Date Issued :	April 28, 2025	PCN Number :	516810
Reason for Change :	Packaging Method/Quantity Changing		
Description of Change :	This notification is to inform you about part(s) listed in this notice that will undergo changes for new Delivery unit and packaging specification change. No changes will be made to the product as a result of this change.		
Assessment of Change :	Drop Test		
Planned Implementation Date :	October 28, 2025		
Customer Sample Availability Date:	June 15, 2025		
Last date to request Samples by Customer : June 30, 2025			
Please note if Samples are not requested as per Customer Samples Request date, it may take additional 4-6 weeks to arrange Samples.

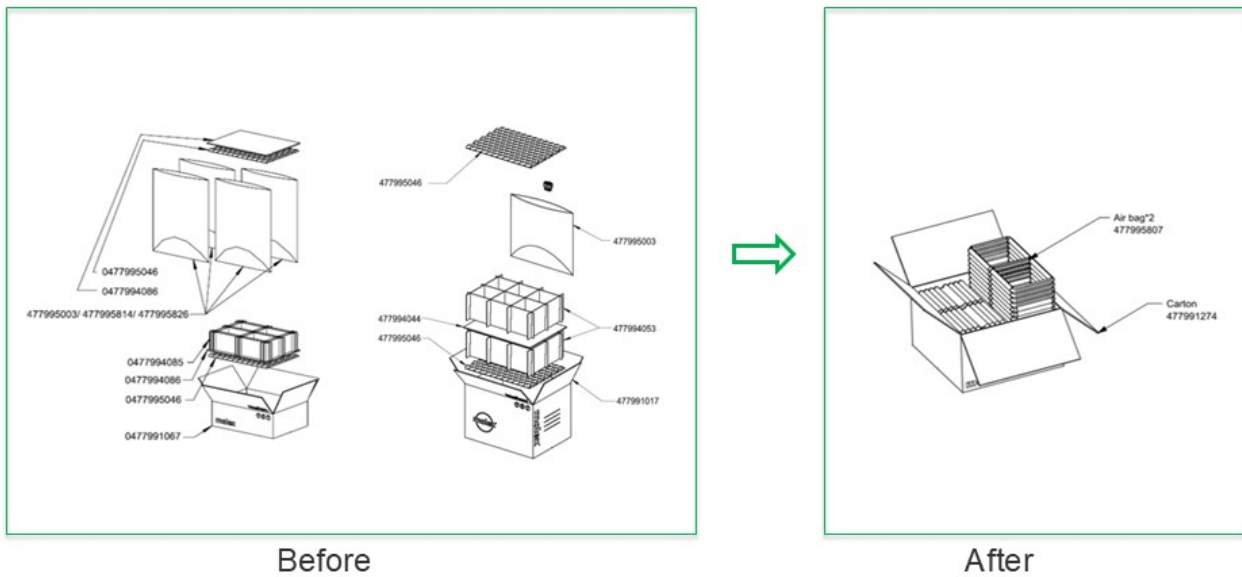
- Change packaging method from partition to air column bag.
- Air bags can provide better protection to products. Meanwhile, it's friendly to employee and environment (Dust caused by assembly of partition can be avoided).
- Some of PNs' DU/SPQ changed. Molex proposed to change packaging method of 131 PNs:
 - ❖ DU/SPQ changed: 103 Part numbers
 - ❖ DU/SPQ keep the same: 28 Part numbers
- Product Impact: No impact to fit, form or function.
- PN impact: Mini50 unsealed
